**DEPARTMENT OF TRANSPORTATION
STATE OF GEORGIA**

SUBJECT APPROVED REVISED CONCEPT REPORT

**DEPARTMENT OF TRANSPORTATION
STATE OF GEORGIA
REVISED PROJECT CONCEPT REPORT**

Project Type:	<u>Intersection Improvement</u>	P.I. Number:	<u>0006932</u>
GDOT District:	<u>District 7</u>	County:	<u>Rockdale</u>
Federal Route Number:	<u>N/A</u>	State Route Number:	<u>N/A</u>
Project Number:	<u>STP-0006-00(932)</u>

Concept Plan by QK4 May 2013 – Relocated Klondike Drive with Roundabout

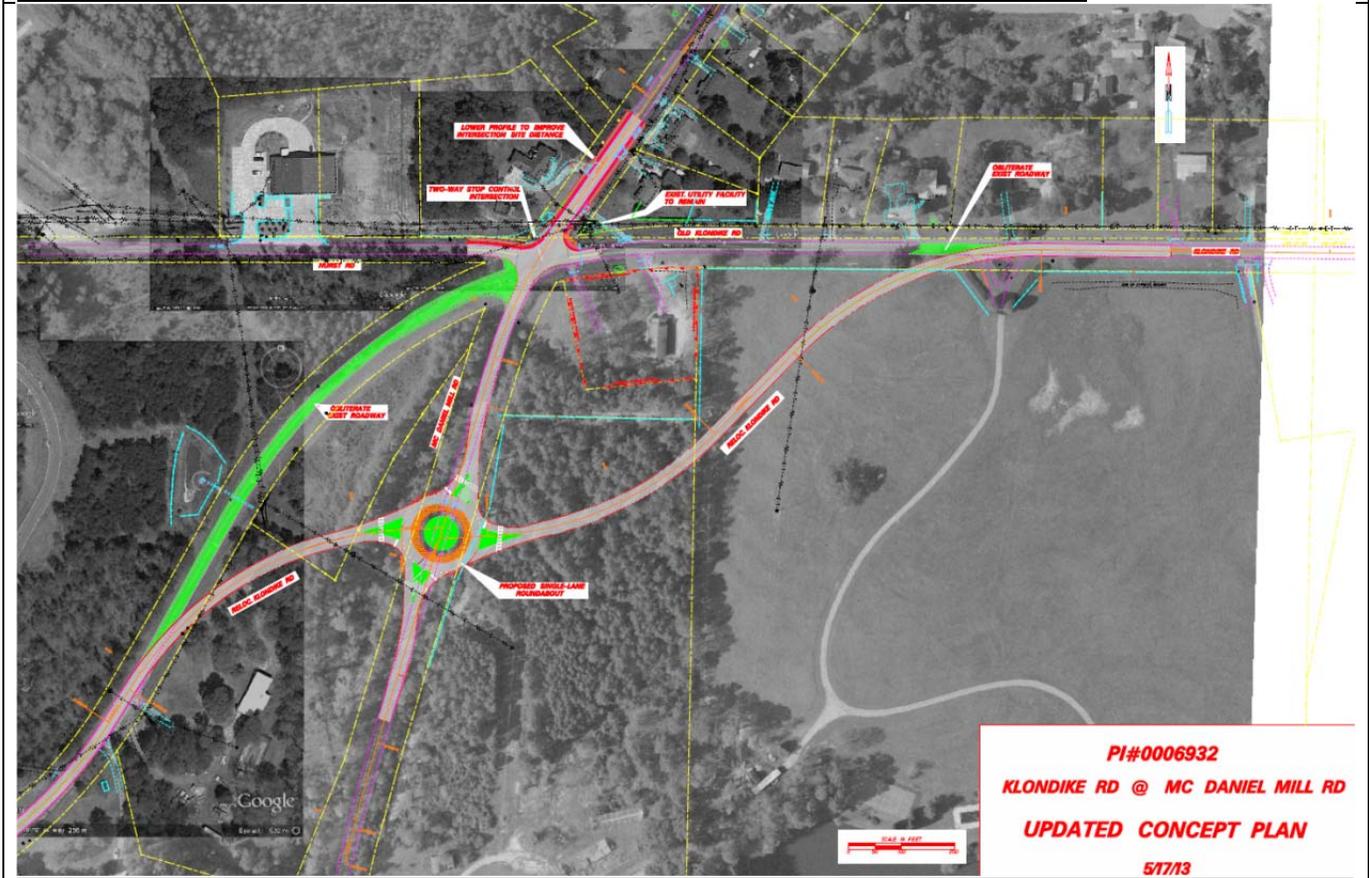
As part of our review for this project we have reviewed the proposed (May 2013) concept roundabout layout developed by QK4 and have developed geometric modifications to improve the skew angle, and ensure optimal safety and overall operations and safety are achieved. To include meeting Fast Path criteria, approach sight distance and minimum centerline radii for the design speed of 45 mph and Large Truck Movements are accommodated (WB-67)

Our review of the proposed (May 2013) concept roundabout layout identified the following recommended modifications:

Please see the revised 160’ ICD MTJ corrective re-design plan sheets attached to include:

ROUNDABOUT CONCEPT

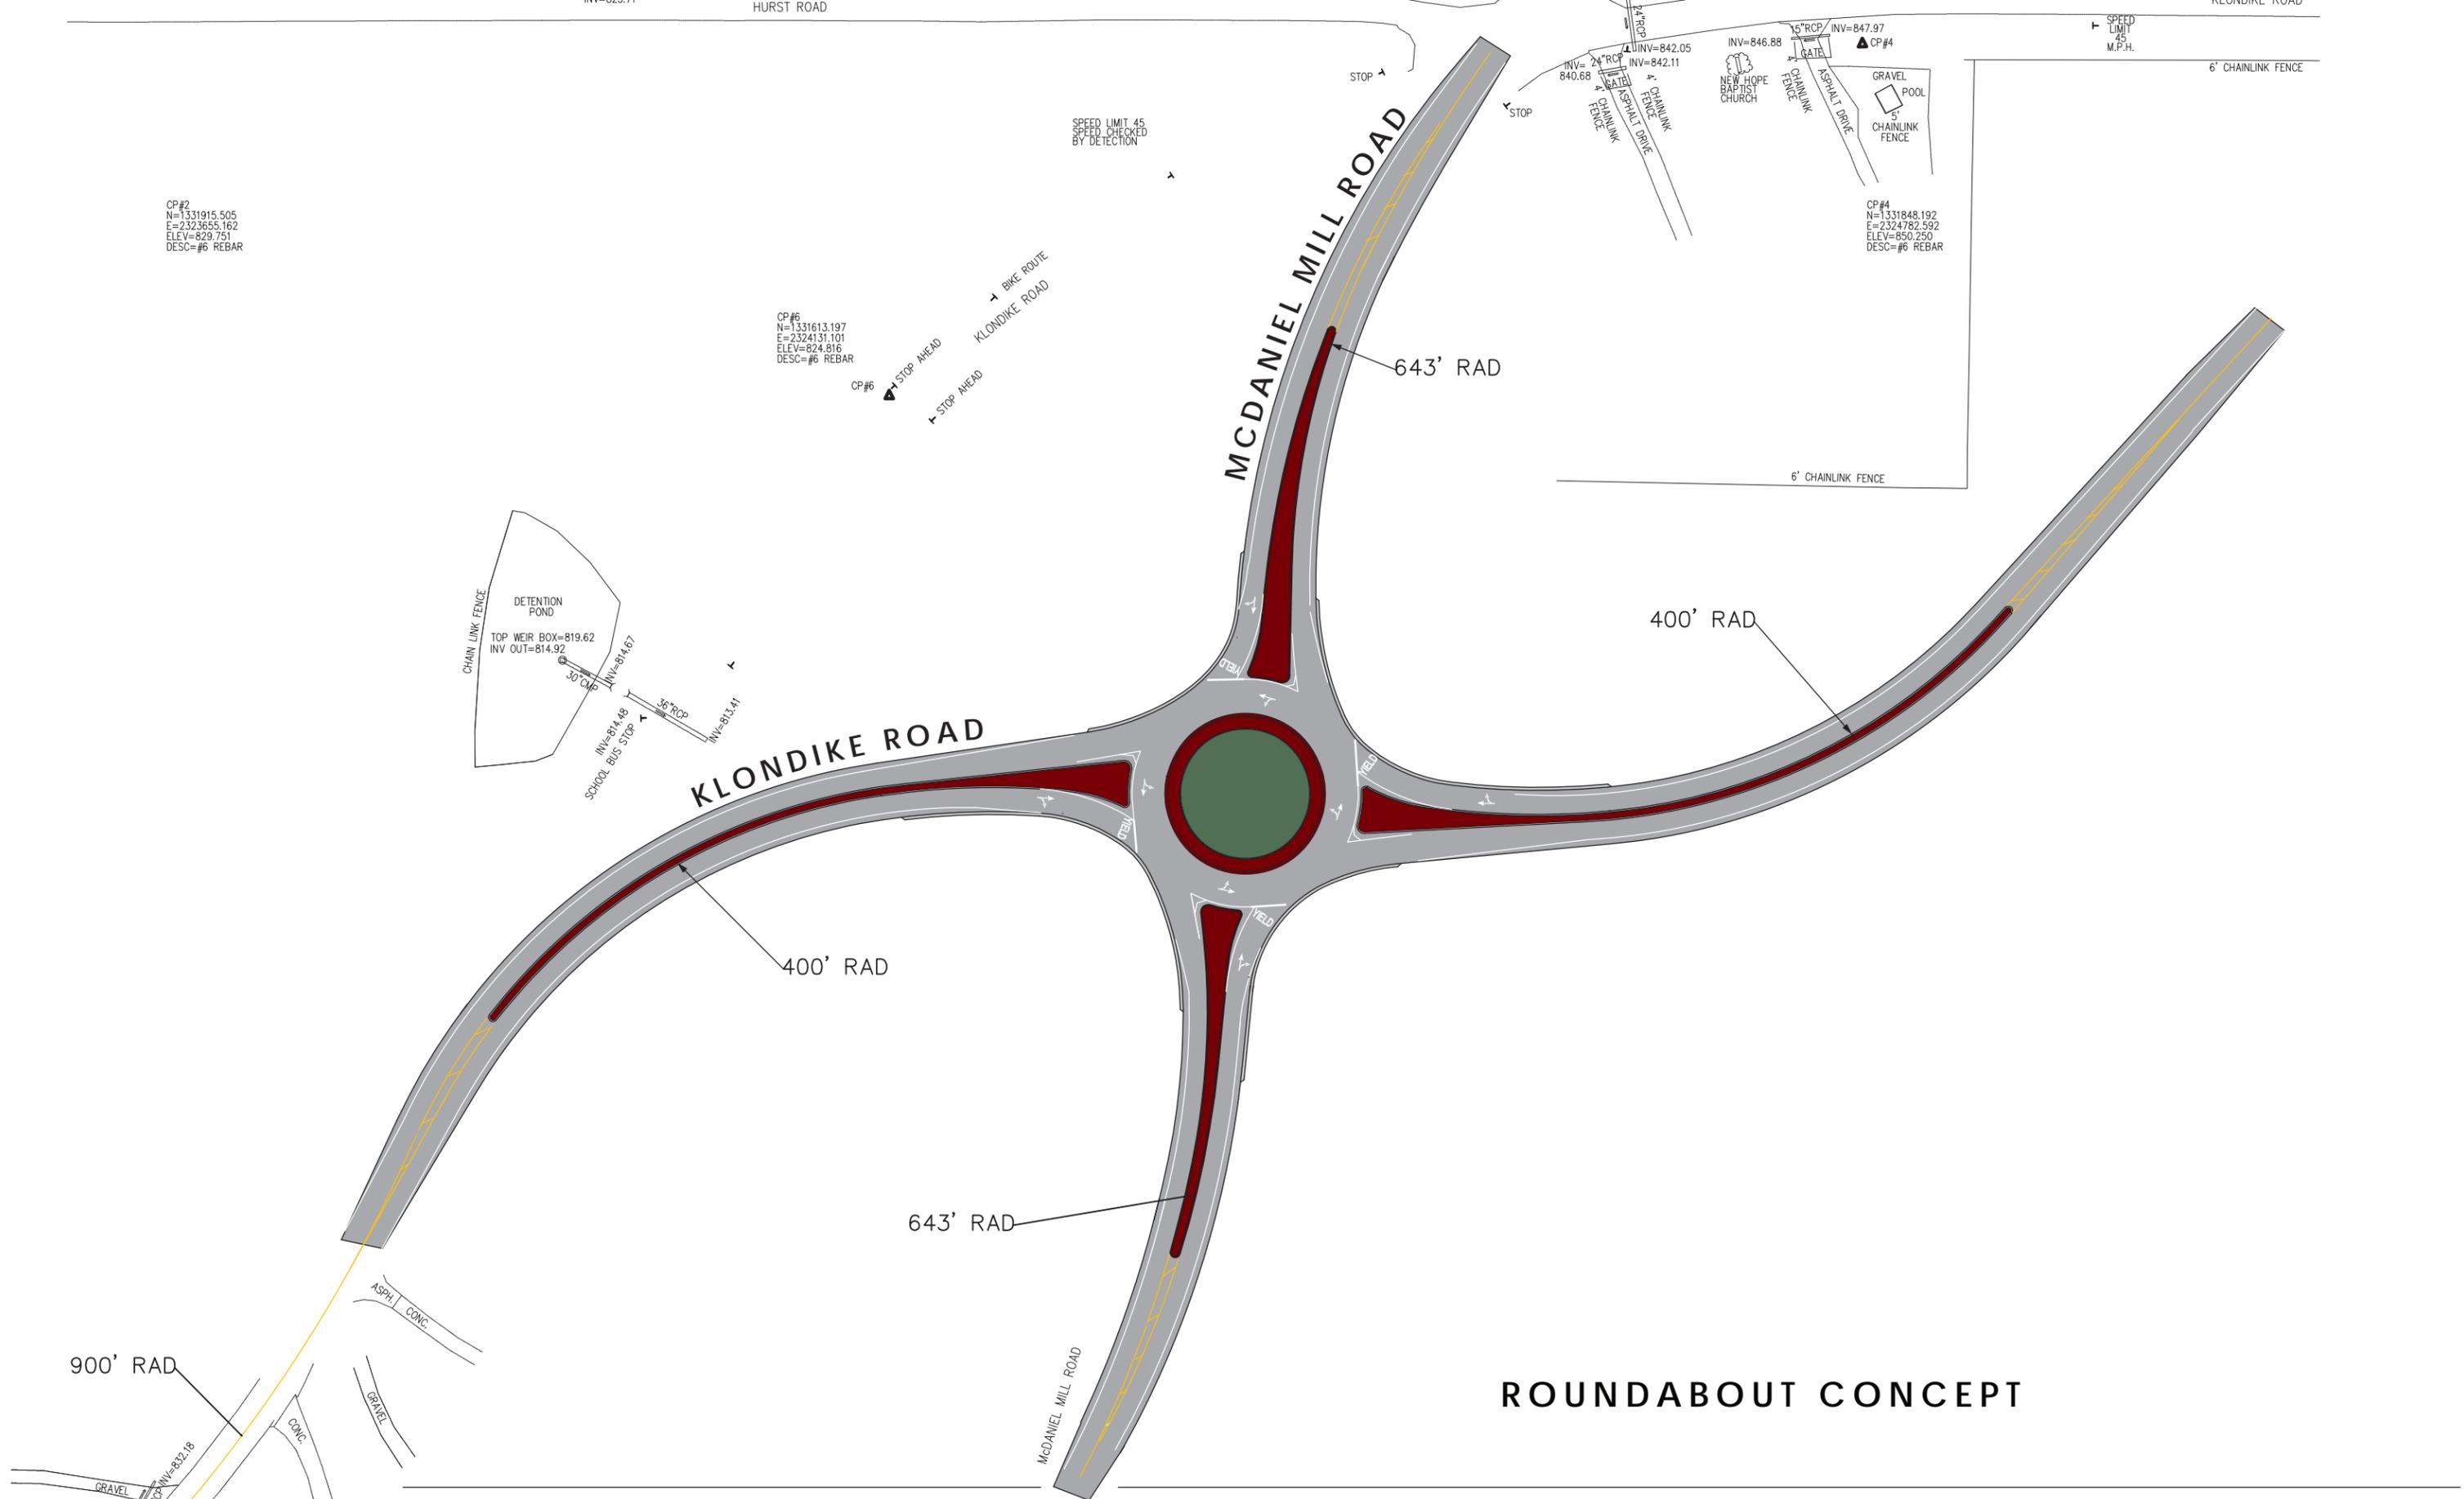
Realigned Klondike Road and 4 Legged Roundabout Intersection:

STOPPING SIGHT DISTANCE

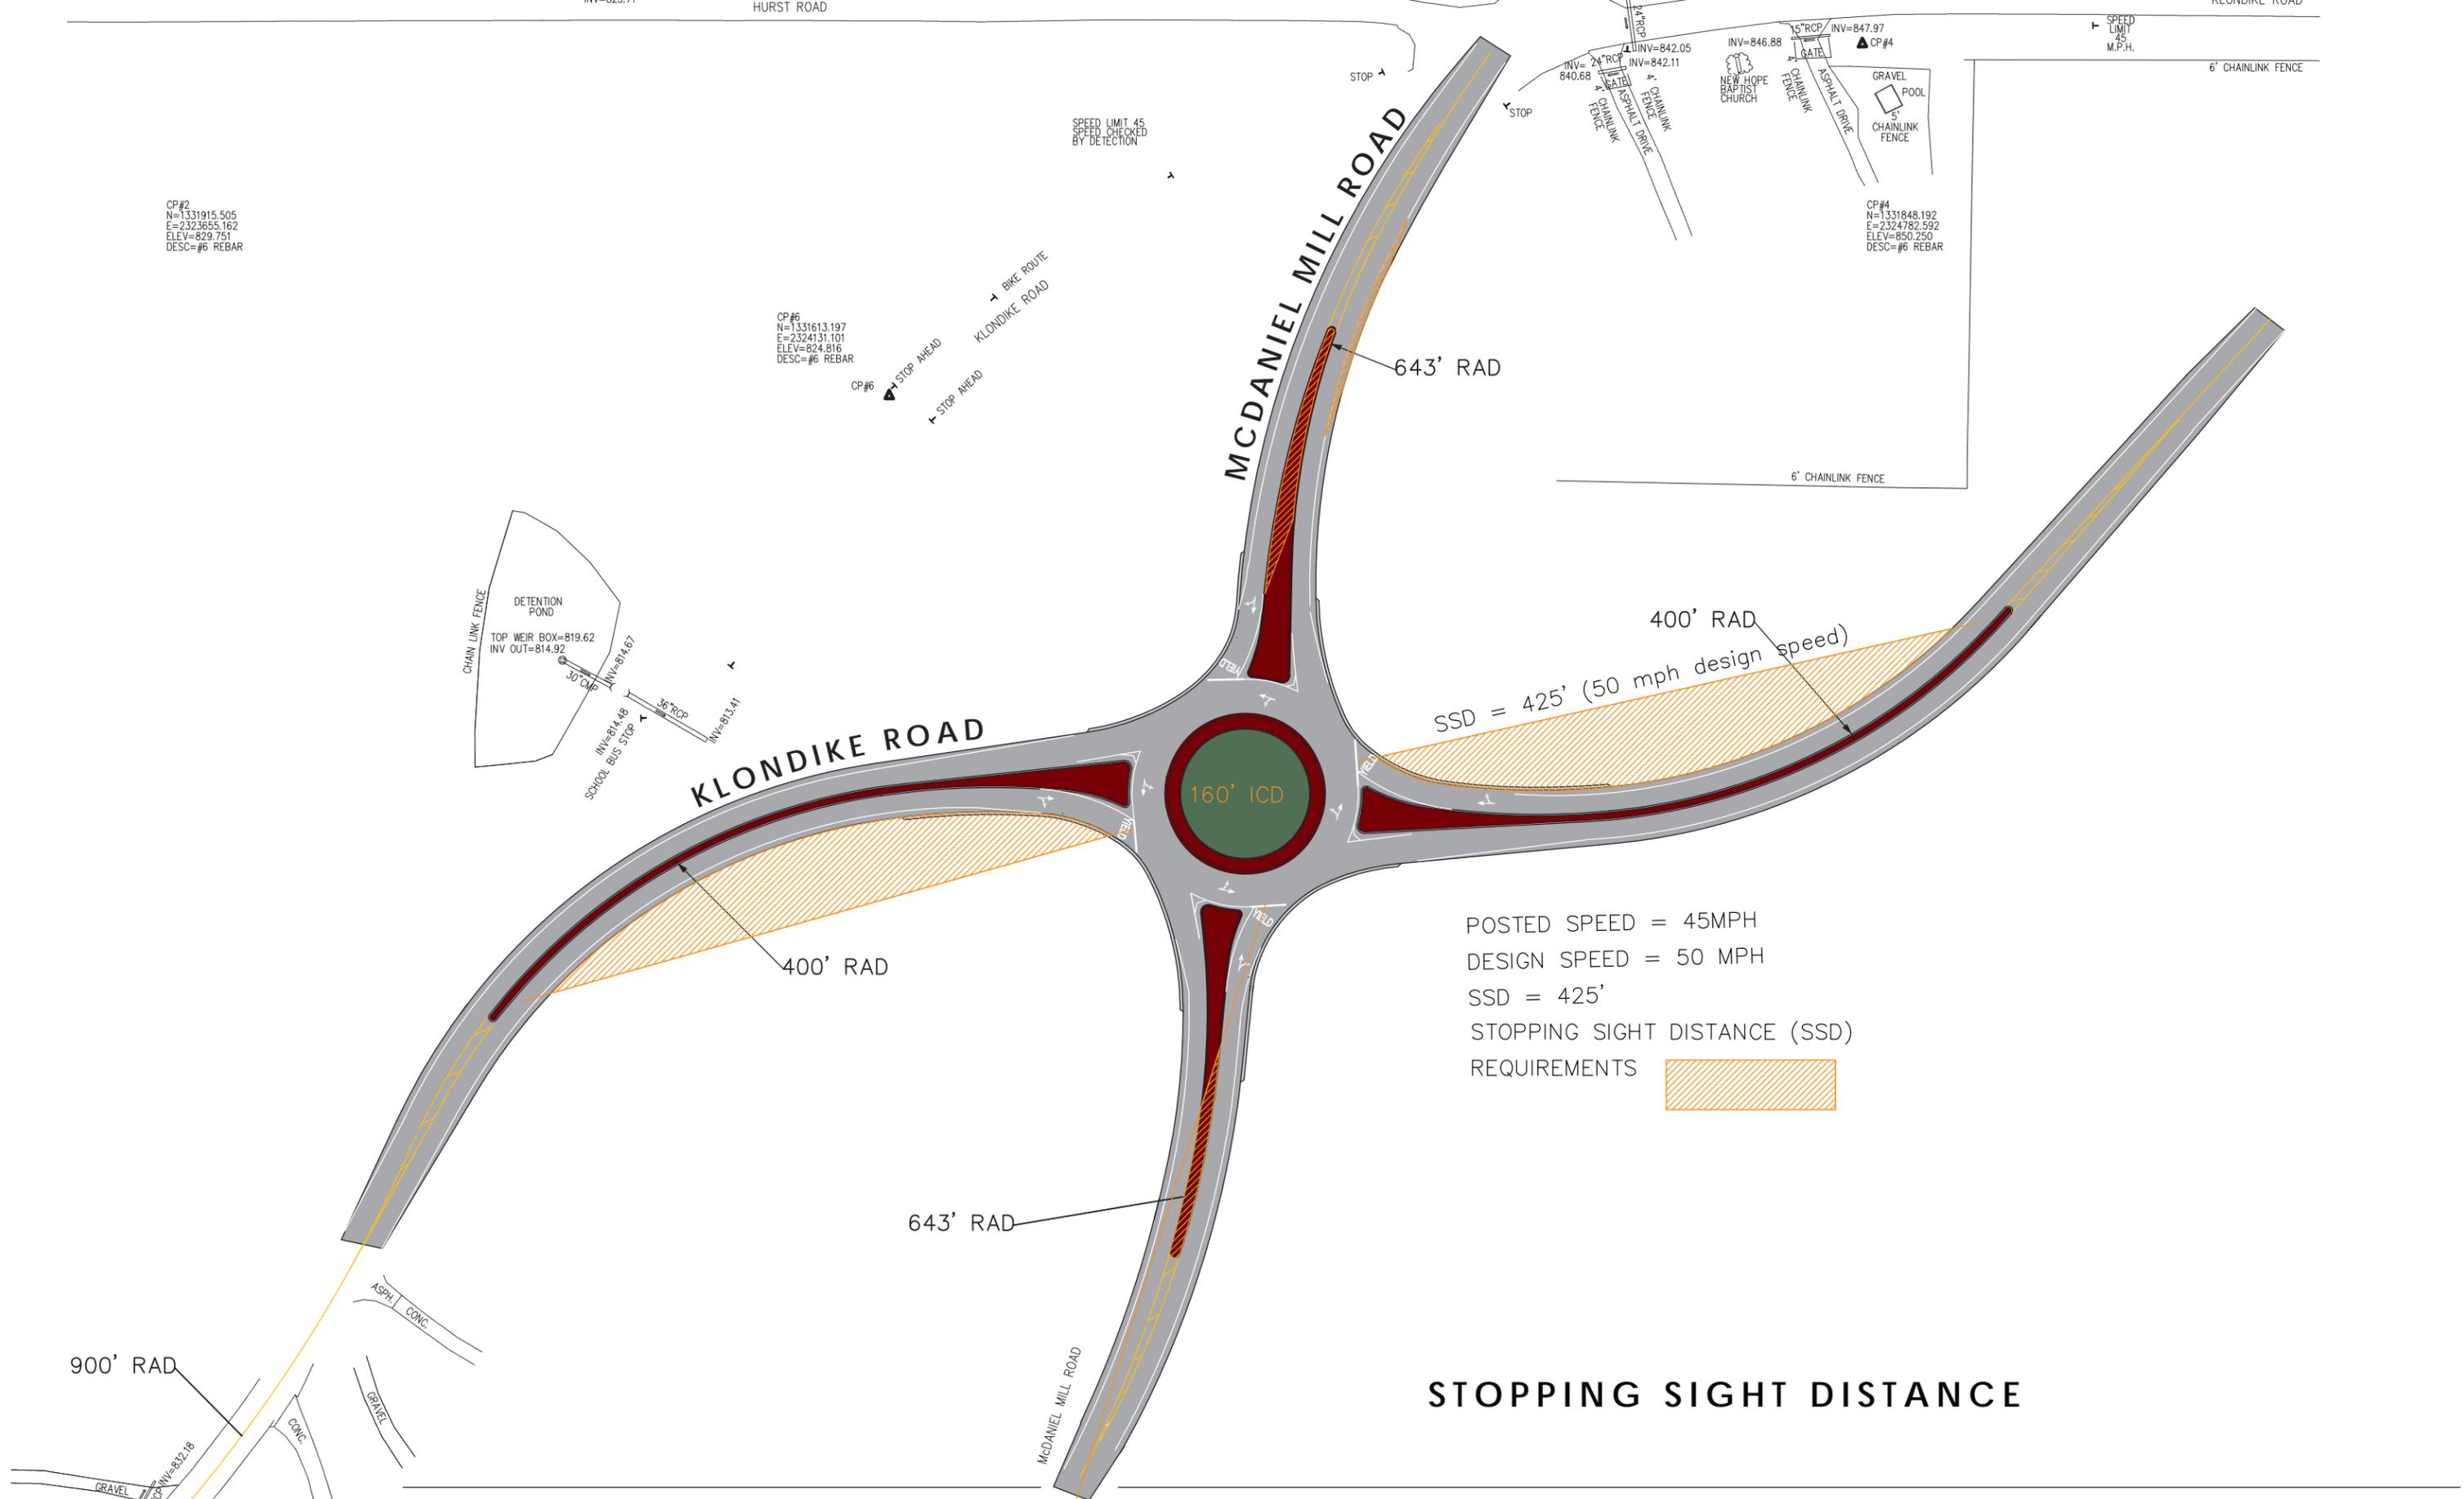
POSTED SPEED = 45MPH
 DESIGN SPEED = 50 MPH
 SSD = 425'
 STOPPING SIGHT DISTANCE (SSD)
 REQUIREMENTS
